Address: **1105 – 1107 BARRENJOEY ROAD, PALM BEACH NSW
2108**

Project: **PROPOSED MIXED USE BUILDING**

Report: **ACCESS ASSESSMENT REPORT**

Date: 15 December 2020

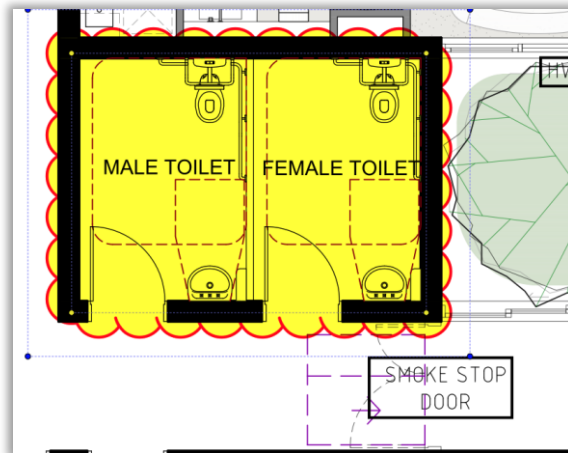
It is acknowledged that the retail tenancy at Ground floor Level is not provided with its own sanitary facilities at this stage.

Please provide commentary in this regard at the CC stage and advise if any facilities are to be provided as part of future fitout/s for the retail tenancy.

Where provided, the facilities must be accessible unisex sanitary compartments to in accordance with Table F2.4(a) and AS1428.1-2009.
